Product Change Notice (PCN)

PCN Number: **PCN-0451185R-01**

Product(s) Affected: PJ-050B

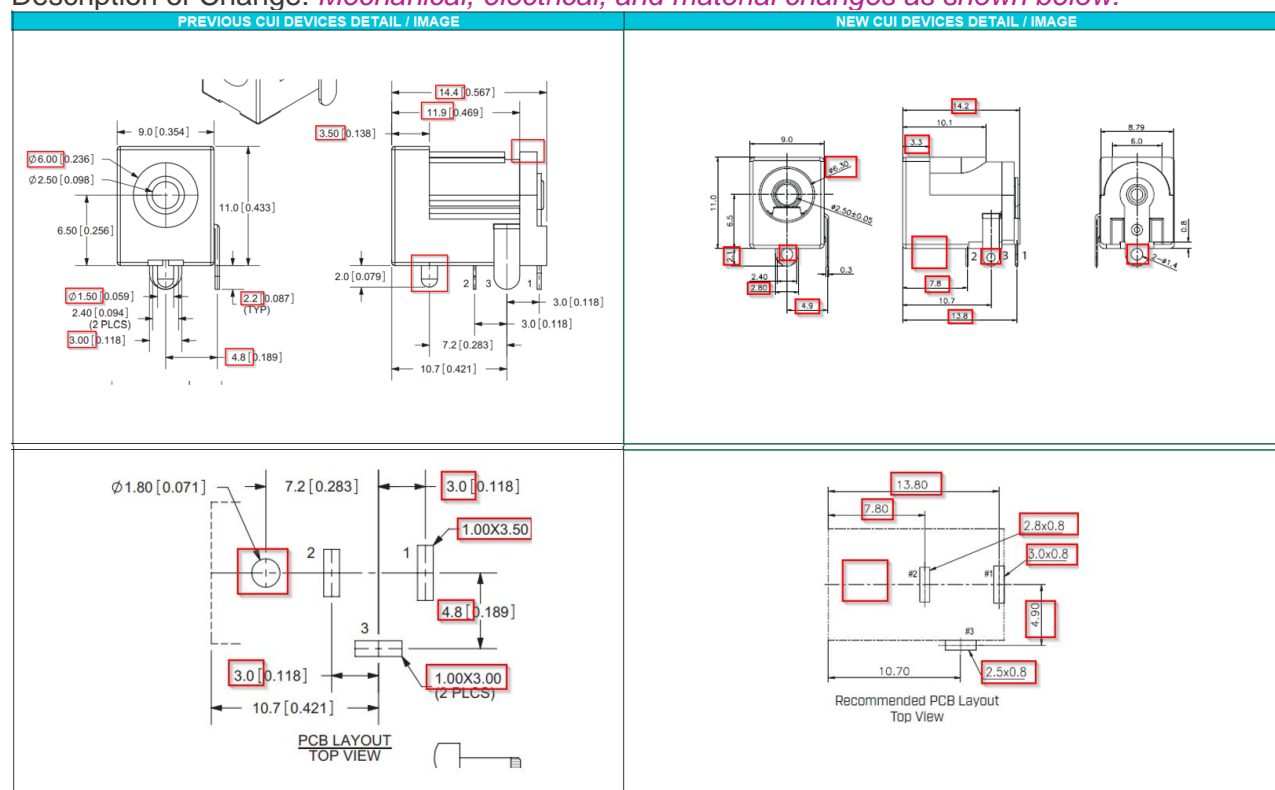
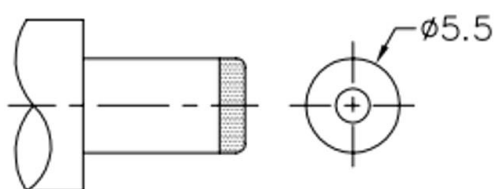
Description of Change: *Mechanical, electrical, and material changes as shown below:*

MATERIAL	PLATING
center pin	copper	nickel
terminal 1	brass	tin
terminal 2	copper alloy	tin
terminal 3	brass	tin
plastic	PBT

MATING PLUG
Jack Insertion Depth: 8.5 mm

Operating temperature range changing to -25C ~ +85C

DESCRIPTION	MATERIAL	PLATING/COLOR
center pin	copper alloy (H65)	nickel
terminal 1	C2680 t=0.35	nickel-silver
terminal 2	C5210 t=0.25	nickel-silver
terminal 3	C2680 t=0.30	nickel-silver
cover	PA9T UL94V-0	black
housing	PA9T UL94V-0	black

MATING PLUG
Jack Insertion Depth: 9.6 mm
